Peer Review Report

Wall Street Place Norwalk, CT

Zoning Commission
and
Redevelopment
Agency

January 5, 2021

Site Plan Diagram

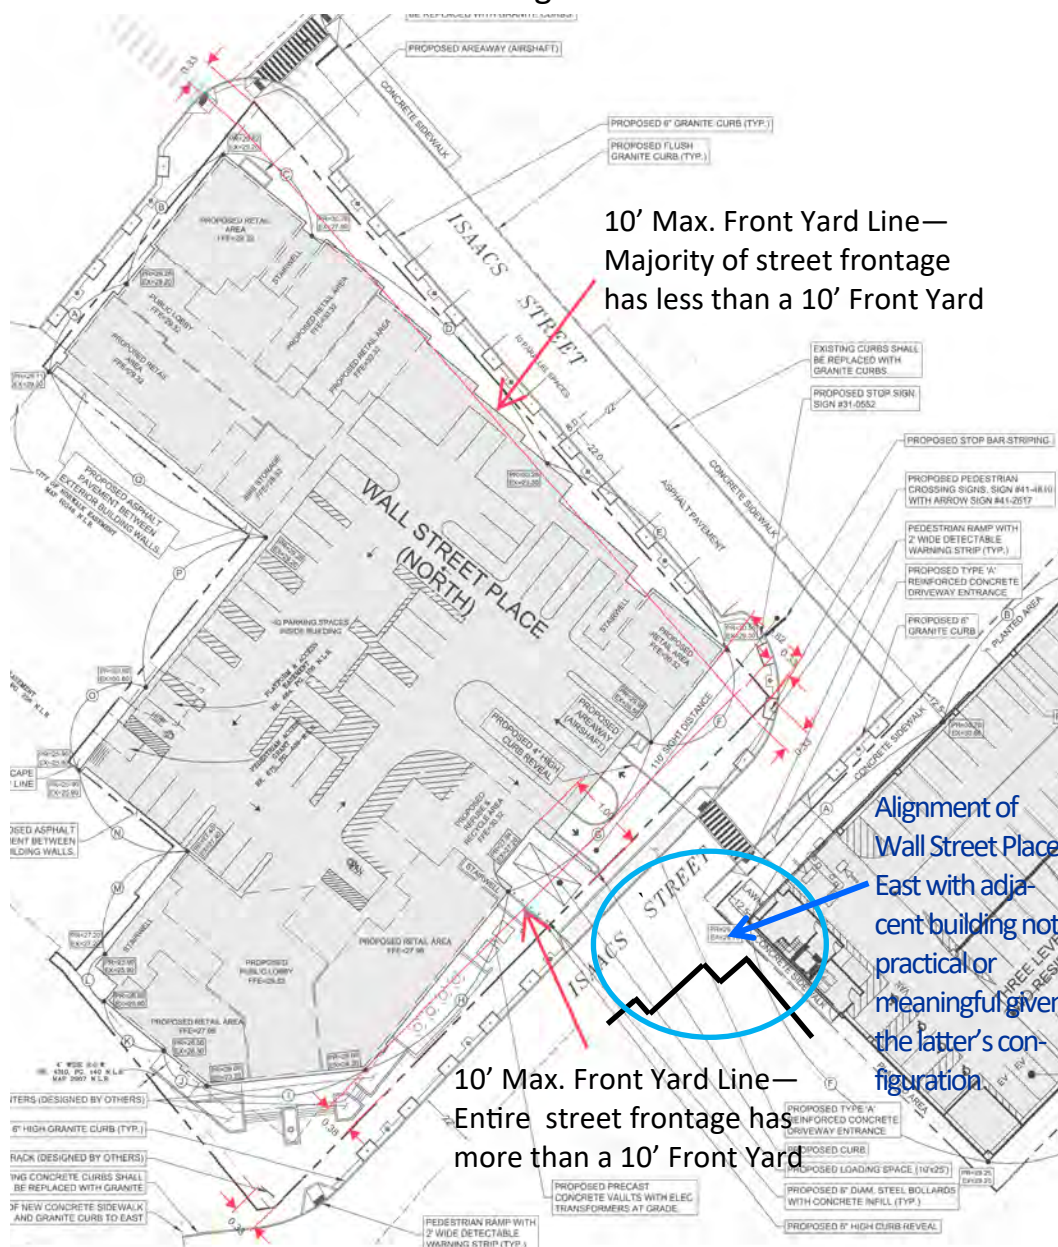
Front Yard Compliance:

1. Along Wall Street, Wall Street Place North is fully compliant.
2. Along Isaacs Street NE, WSP North is fully compliant.
3. Along Isaacs Street SE, WSP North is compliant under 118-504 C (14).

4. Along Isaacs Street SE, WSP East is within the allowed maximum 10' Front Yard if measured from the required sidewalk width. The requirement for a maximum setback is created to provide a generally harmonious streetscape with comparable building setbacks with adjacent structures existing or planned. In this particular case, the only relevant neighboring structure is The Phoenix on Isaacs, a building with multiple steps back in its façade. WSP East is designed to generally align with the most prominent of these, thereby complying with the intent of the Ordinance and Neighborhood Plan.

5. Note: the building corner at the SW end of Isaacs SW is cut back at an angle anticipating the creation of a public space in future adjacent projects as envisioned in the 2008 master planning.

Yard Compliance Mitigation Diagram

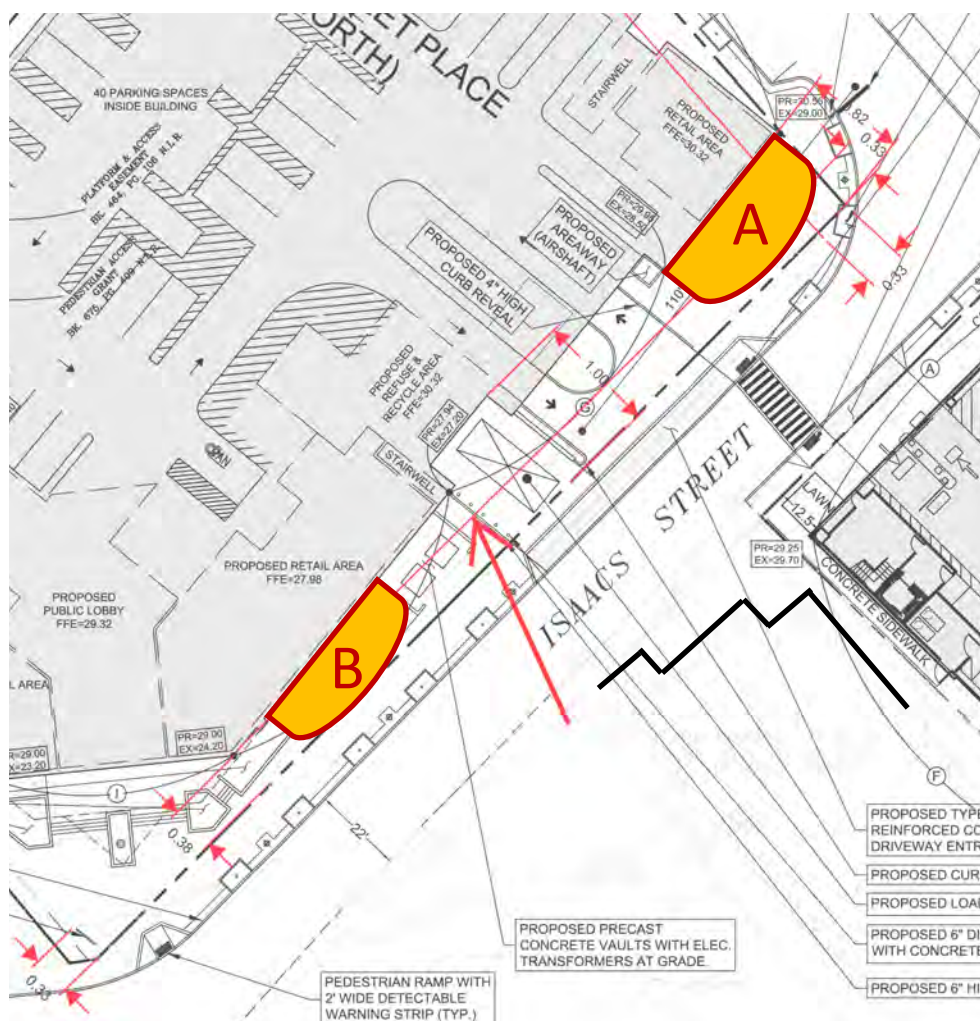
While the footprint of the existing building, WSP North, is grandfathered under 118-504 C (13), it could also be made more compliant to the intent of the current with respect to front yards along Isaac's Street SE without impinging on the integrity of the existing structure.

Two one story commercial/retail bays—A and B, above— could be added to the existing building. These would fill at least a portion of the overly large front yard, particularly at the sensitive corner where Isaac's Street bends to the southwest. The forms shown above are only meant to be suggestive and it would be up to the project's architect to develop a proper plan form and integrate its three dimensional realization into the remainder of the building.

Functionally these would add space to the existing retail spaces proposed in the Application. Visually, these bays would be a great focus of interest for the pedestrian walking Isaac's and would have the salutary effect of drawing attention away from the necessary, but pedestrian dulling, experience of the vehicular garage entry and the loading dock / refuse area.

Wall Street Place East from Commercial street showing parklet and evergreen garage screenings.

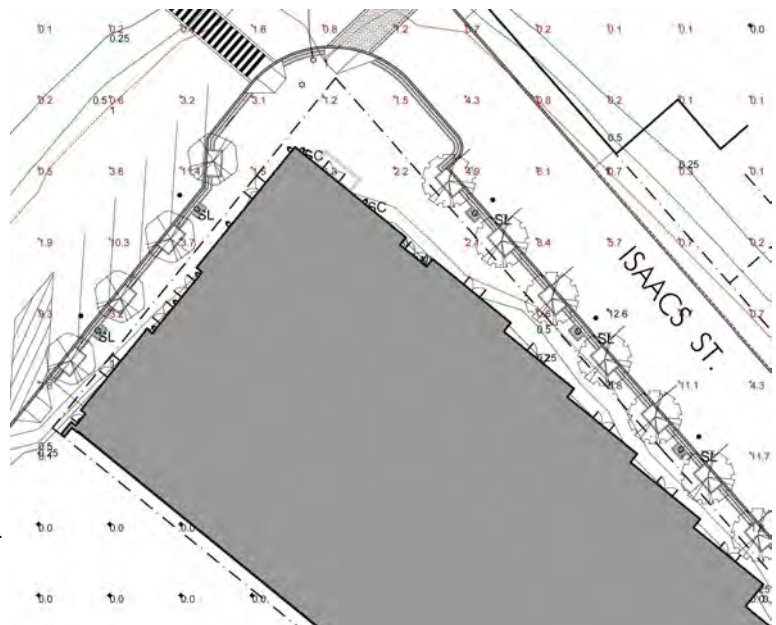
- A parklet is included to the east and southeast of Wall Street Place East.

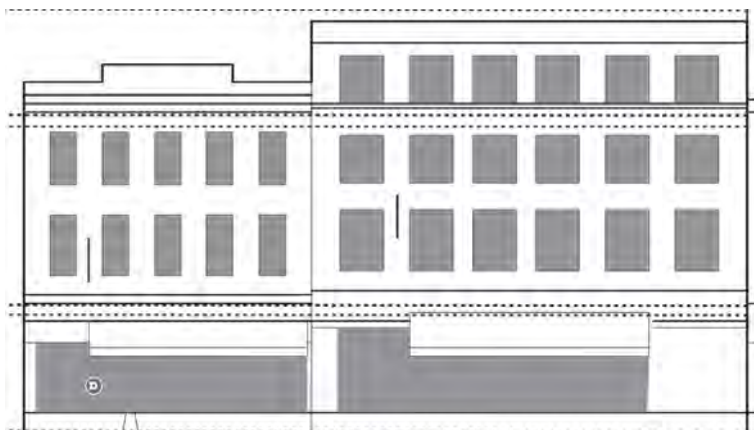
- The Applicant has provided a drawing analyzing the Transparency of the West Avenue portion of their storefront, representative of commercial spaces in their building.
- The Design Guidelines provide a diagram of a façade and a standard that their shall be a “Minimum 75% transparent surface at ground floor”. This standard raises several questions:

$$74' \text{ storefront} \\ 74 / 94.83 = 78.03\% \text{ OPEN}$$

1. Does this standard pertain to all street frontages or only commercial street frontages. While commercial space is desirable, it does not appear that there is a regulatory requirement that all ground floor streetfront space be commercial. It is the recommendation of this Report that only commercial space be held to the 75% rule.
2. Does this requirement specify that every element of storefront *individually* conform to the 75% requirement or can one aggregate all the storefront into one unit that in total meets the requirement. It is the Recommendation of this Report that aggregation is an acceptable approach to compliance.
3. The Guidelines diagram shows first floor areas as representative of the transparency desired. Of note, the transparency shown (approximately 80% aggregate over the

It is the recommendation of this Report that only items that can actually be seen through undistorted be considered transparent.

Storefront with large show windows from Applicants Material Board

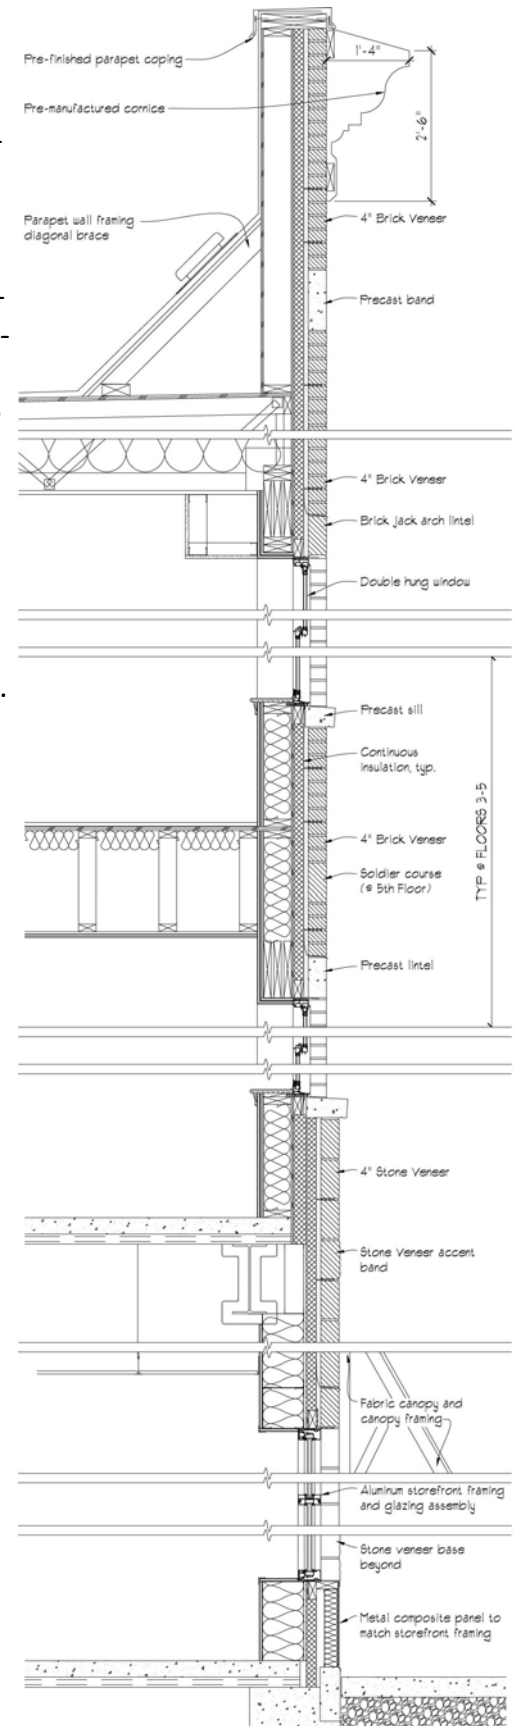
- As a separate issue, historical storefront typically has very wide glass panes for show windows (much wider than upper story windows) as shown in the examples on preceding pages and to the right and below. The appropriateness of these large windows is also shown by the example from the Applicants Material Board showing a large show window storefront.

The Applicant has provided and alternate a design of the project's show windows with significantly wider window panes for Commission consideration. It is the recommendation of this Report that this alternative with larger show windows be accepted.

5. That the design proceed with the larger show windows as discussed in (see Design Guidelines, Building Architectural Design, C. Building Facades, Ground Floor Transparency)

Wall Section WSP North

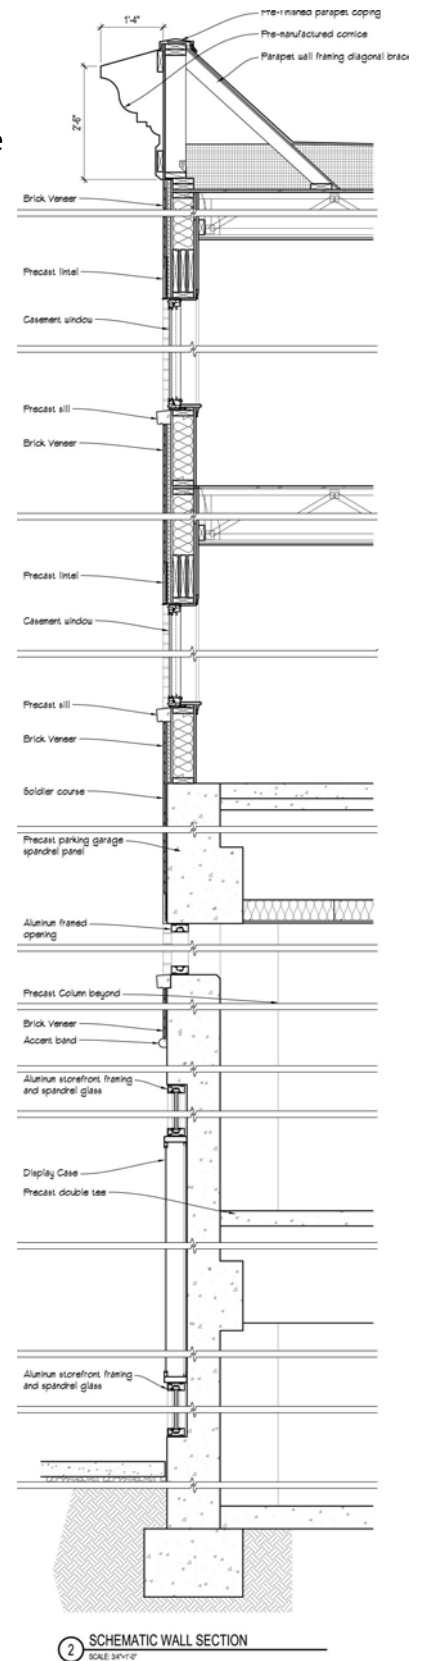
- Wall Street Place North
 - The building is proposed to be clad in full 4" nominal depth cast stone on the 1st floor with 4" nom. brick on the stories above as shown in the wall section to the right. These materials are considered to be of appropriate quality for a building under these regulations. The 4" base veneer is particularly important as, historically, this type of construction is recognized as durable and appropriate for long-term low maintenance use in an urban environment. Elevations and the material board show a rusticated base within the 1st floor with smooth units above.

- The storefront wall section specifies a base panel which is not present in any elevations. This discrepancy needs to be reconciled. There should be at least a 12" masonry base course at the storefront to provide long term durability.

- A premanufactured cornice of unspecified material crowns the wall.
 - Both storefront and unit windows are recessed from the building façade plane by about 3". This, along with the projecting lintels and cornice provide a rendering in depth as required by the Guidelines.

6. Provide the following: (see Design Guidelines, Building Architectural Design, C. Building Facades, Render with Texture and Depth)
 - a. A durable masonry base at least 12' in height at storefront sections.
